ARIZONA DEPARTMENT OF TRANSPORTATION
ROADWAY ENGINEERING GROUP
OFFICE MEMO

RE: Revisions to Construction Standards - Metric Version

RE: ERRATA SHEET - METRIC

STATE OF ARIZONA DEPARTMENT OF TRANSPORTATION INTERMODAL TRANSPORTATION DIVISION STANDARD DRAWINGS	REV. 5/97
	CATCH BASIN, MEDIAN FLUSH	DRAWING NO. C-15.80

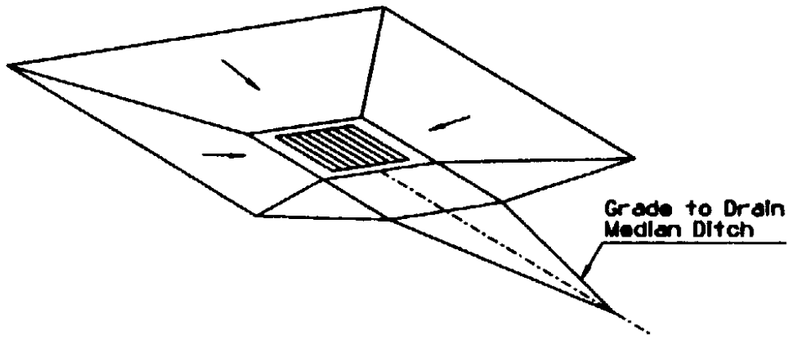
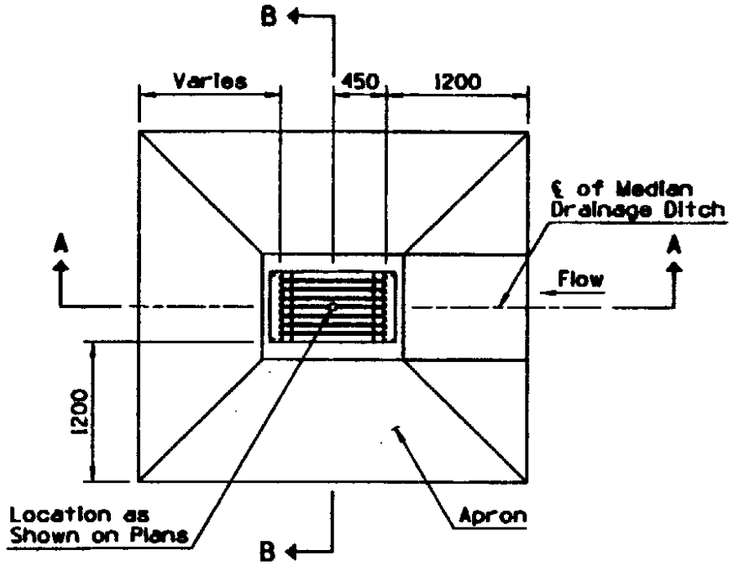
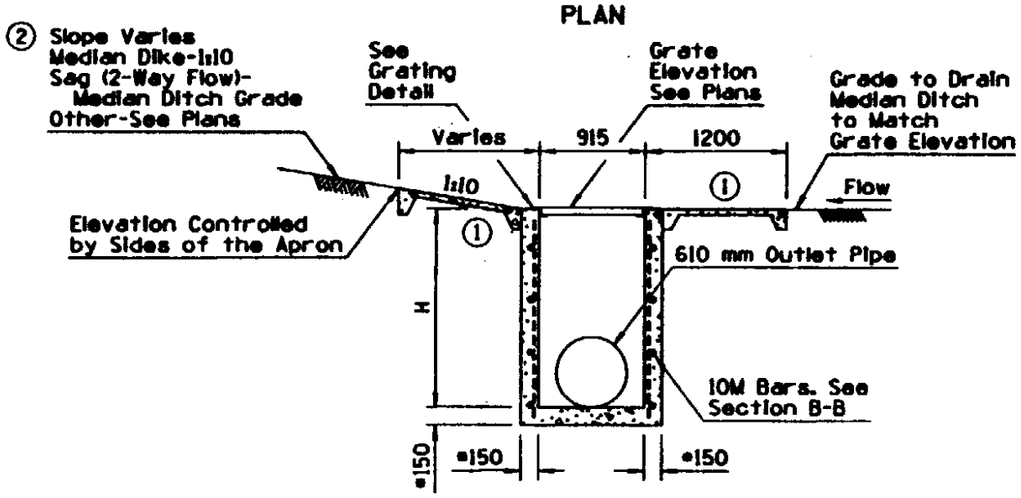
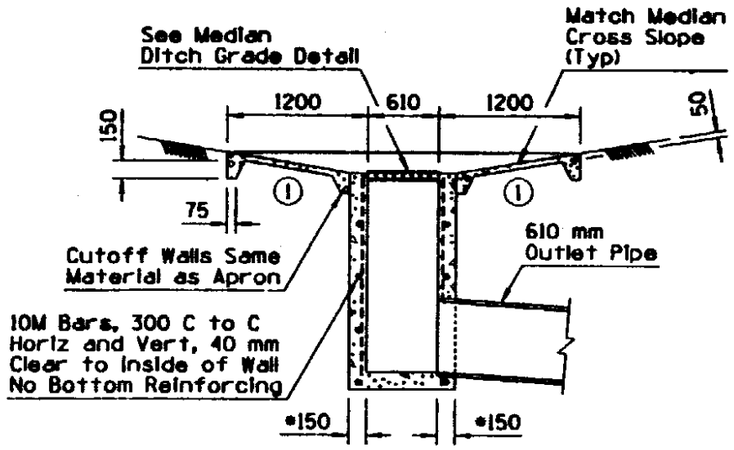
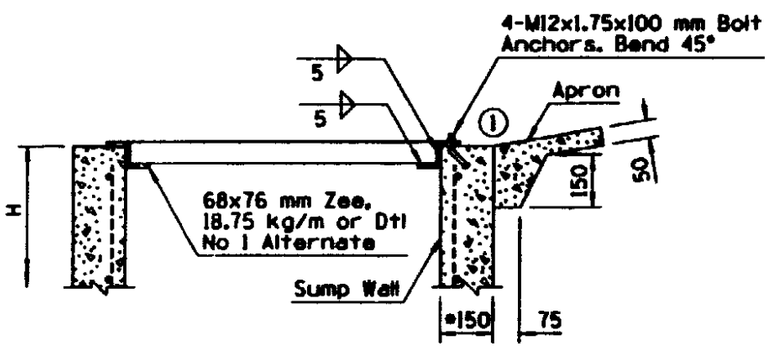
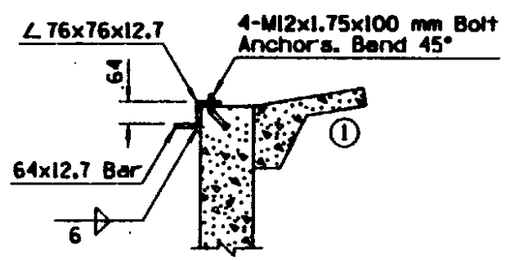
NO	DESCRIPTION OF REVISIONS	MADE BY	DATE
1	CHANGED APRON TO PORTLAND CEMENT CONCRETE ONLY	PNB	5/97
2	REVISED SLOPE	PNB	5/97
3			
4

DESIGN APPROVED Terry H. Otterman	STATE OF ARIZONA DEPARTMENT OF TRANSPORTATION INTERMODAL TRANSPORTATION DIVISION STANDARD DRAWINGS	REV. 5/97
APPROVED FOR DISTRIBUTION	CATCH BASIN, MEDIAN SIDE SLOPE	DRAWING NO. C-15.81

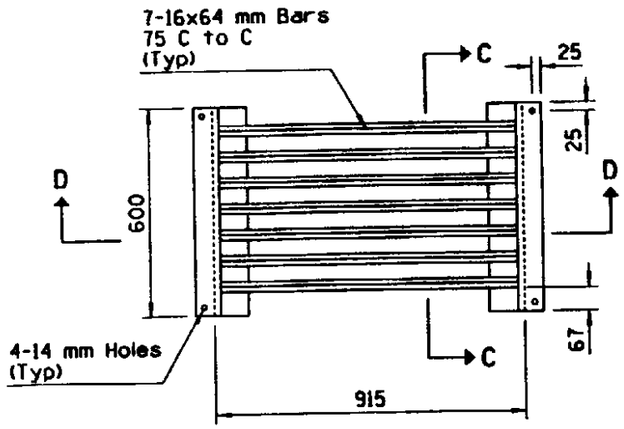
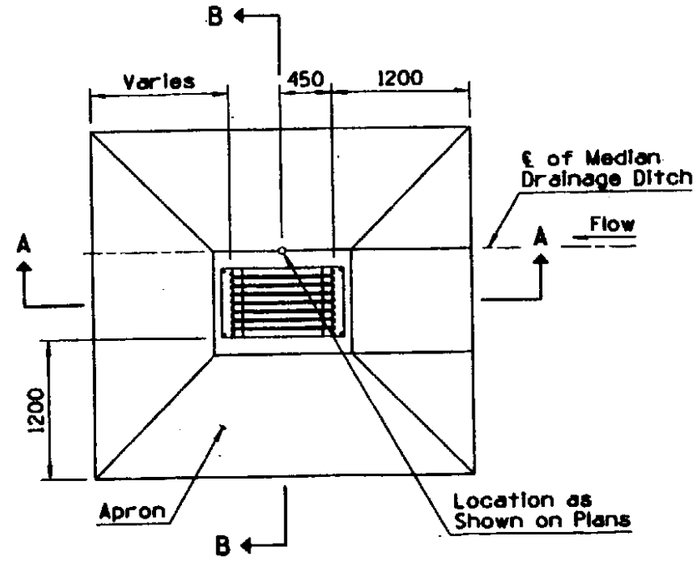
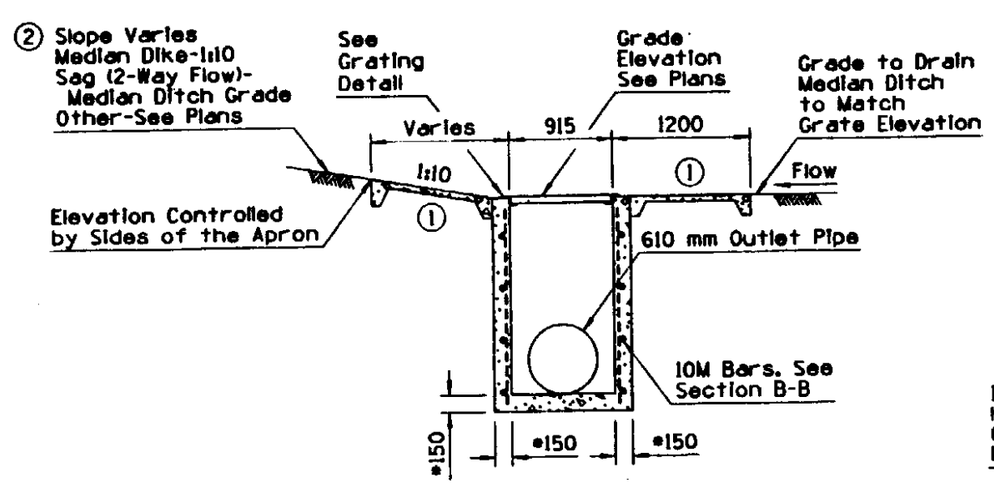
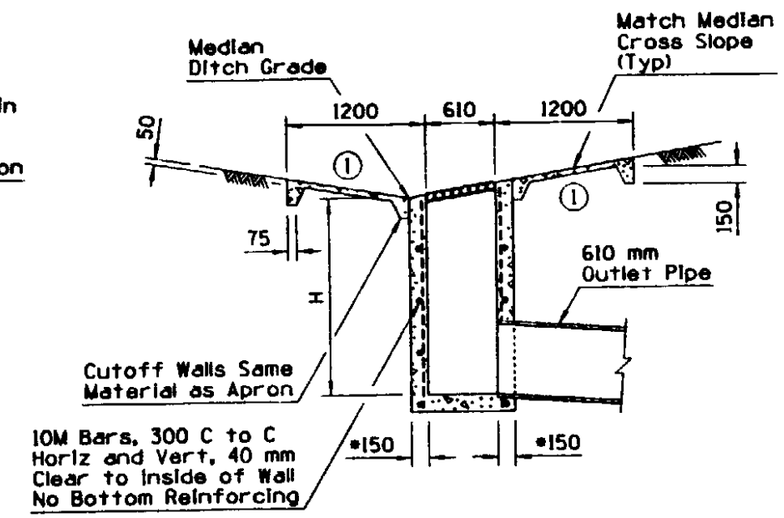
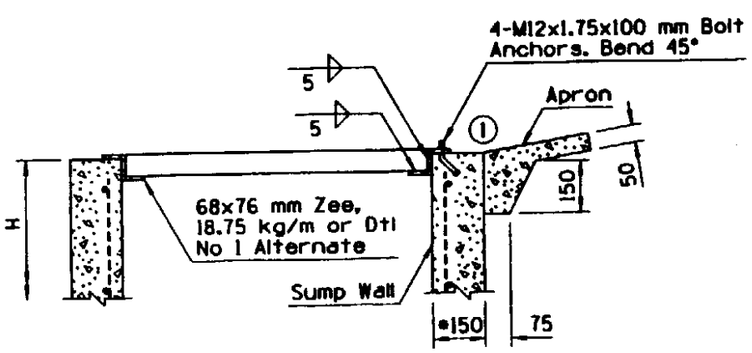
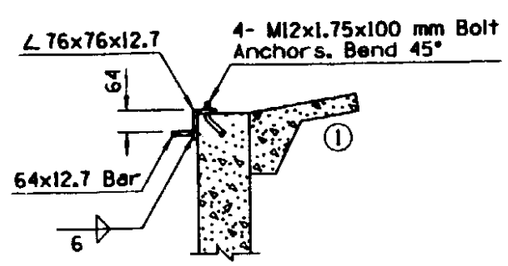
NO	DESCRIPTION OF REVISIONS	MADE BY	DATE
1	CHANGED APRON TO PORTLAND CEMENT CONCRETE ONLY	PNB	5/97
2	REVISED SLOPE	PNB	5/97
3			
4
